RECEIPT DATE: 7-29-19 **ONSITE SEWAGE DISPOSAL SYSTEM** P 965575

RE: 2385 Rt. 97
Cooksville, MD 21723
"Septic Plan Comments"

**SEPTIC SYSTEM INSTALLATION SITE PLAN**  
**2385 MARYLAND ROUTE 97**  
 ZONED: RC-DEO  
 TAX MAP 14 GRID 11 PARCEL 253  
 FOURTH ELECTION DISTRICT HOWARD COUNTY, MARYLAND  
 SCALE: 1" = 40' DATE: OCTOBER, 2018  
 SHEET 1 OF 1

**INITIAL SYSTEM**  
 SEWAGE DISPOSAL SYSTEM DATA, DESIGN FOR 3 BEDROOMS

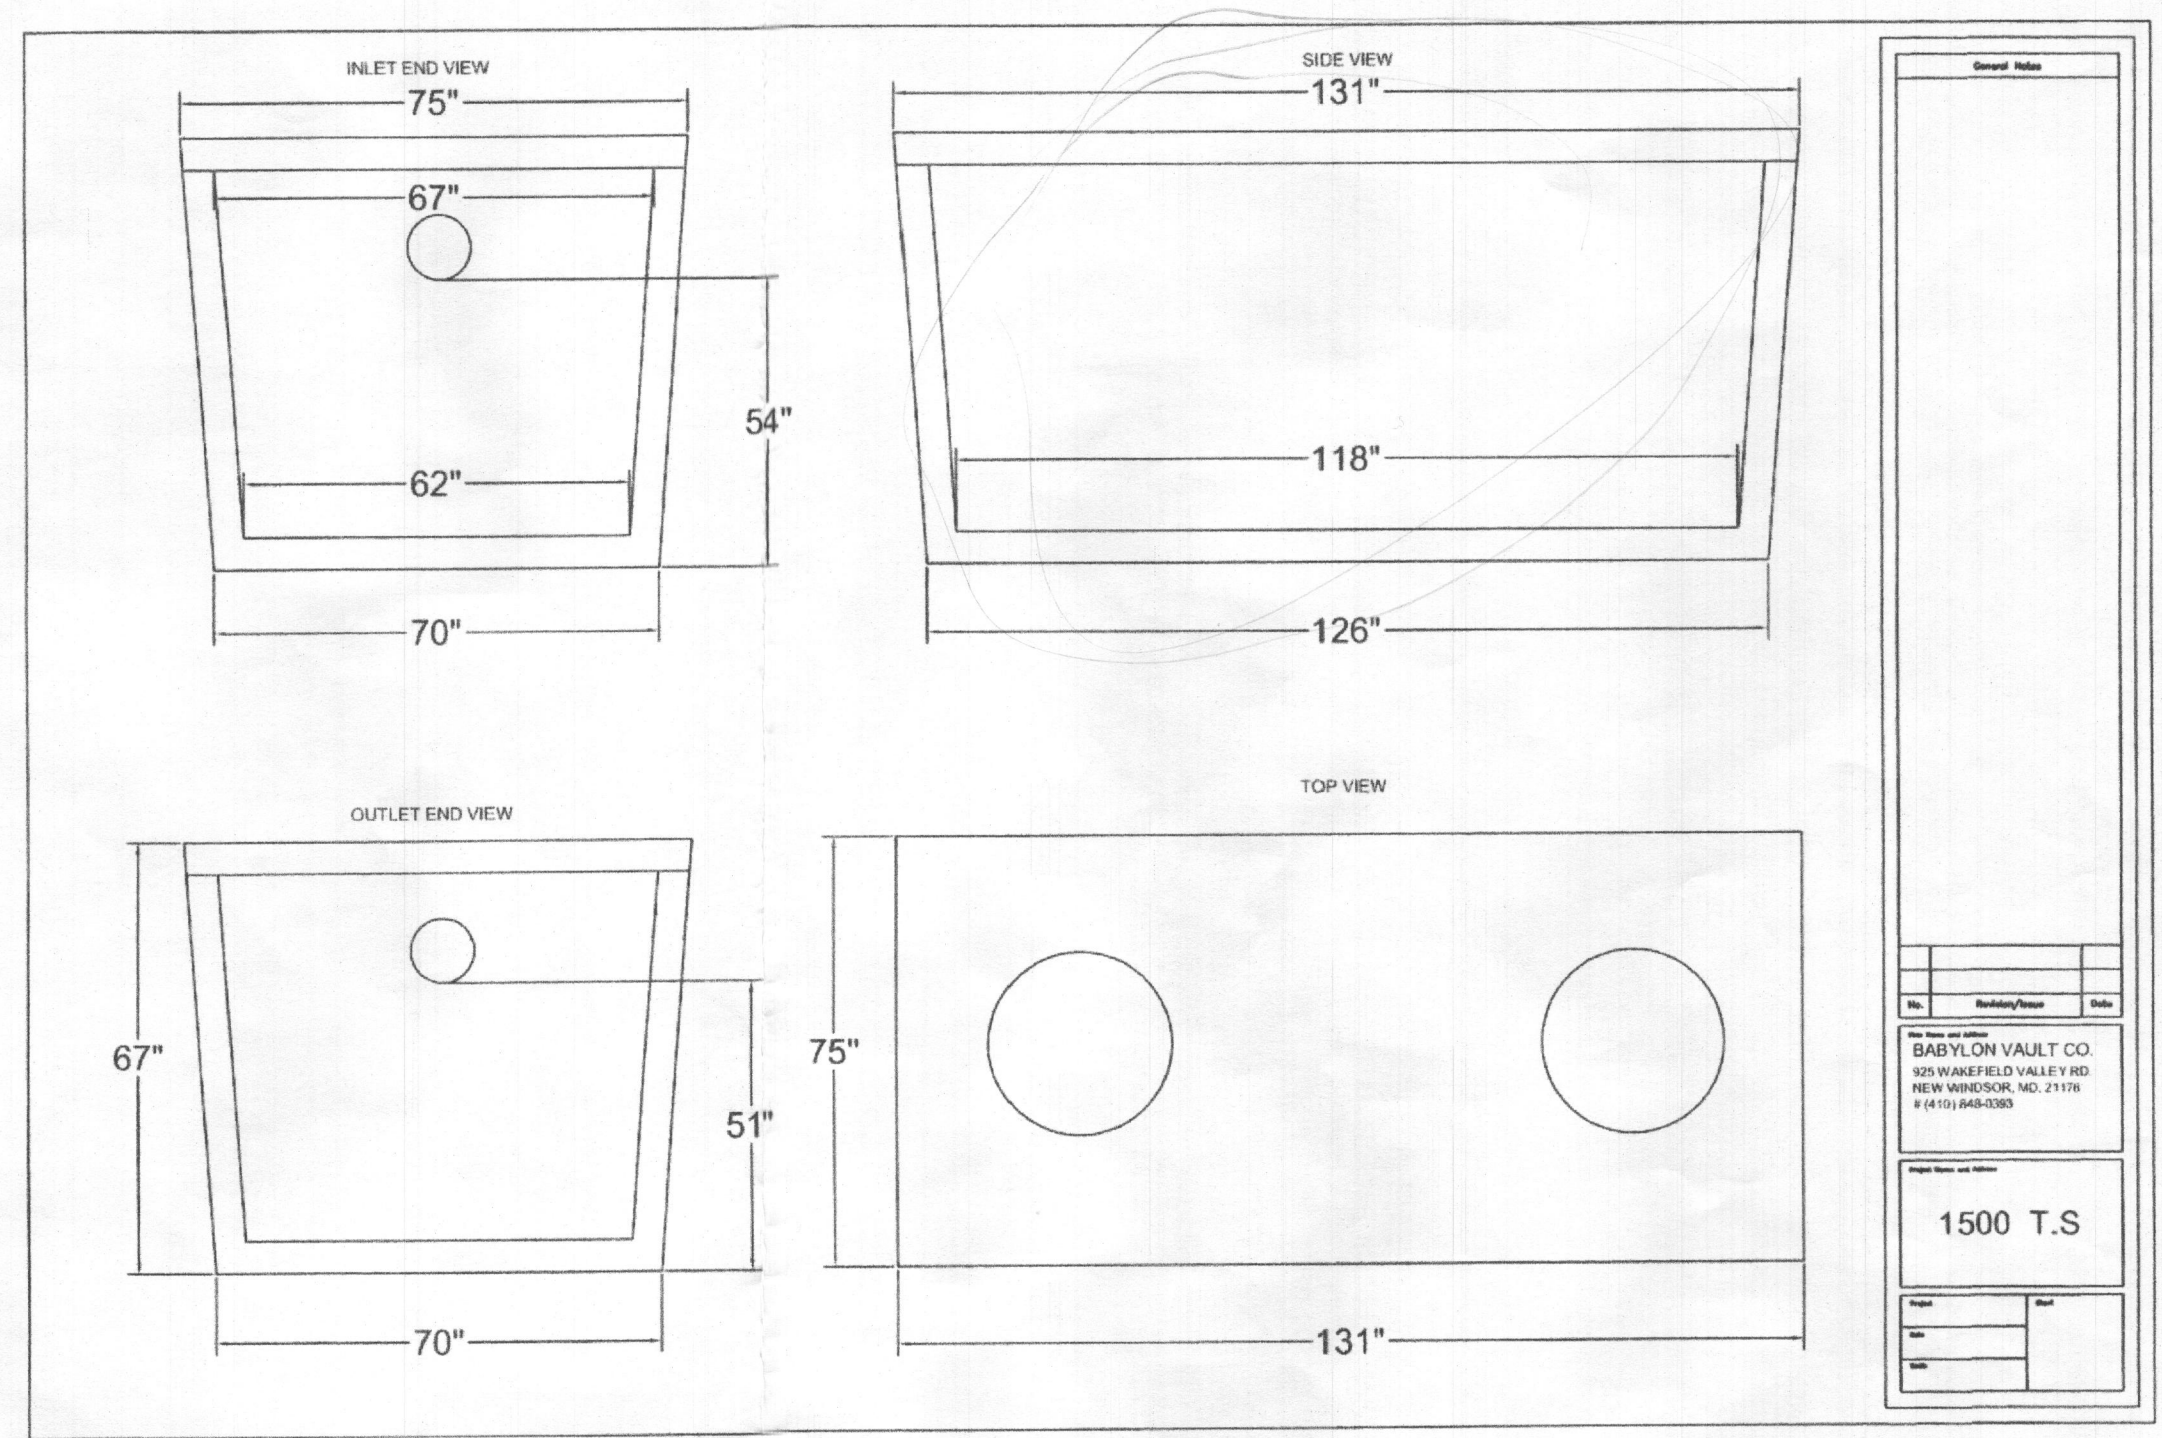
- Septic Profile W/zone Labeled Side
- + Initial Trench data 3' Invert Detail class 4'
- + Bottom of Trench shown as 4' head, 3' to be 3' for initial
- Invert to 2'
- Potential Basement Bedroom
- Septic Tank under center wall
- Rectangular?
- Alternate well sites need to be visible.
- clearly label trenches. Too many trenches.
- Show trenches whole
- Consider to remain or remove
- Label garage shed
- Put well tag with well
- Pull Trenches back to top of SDA
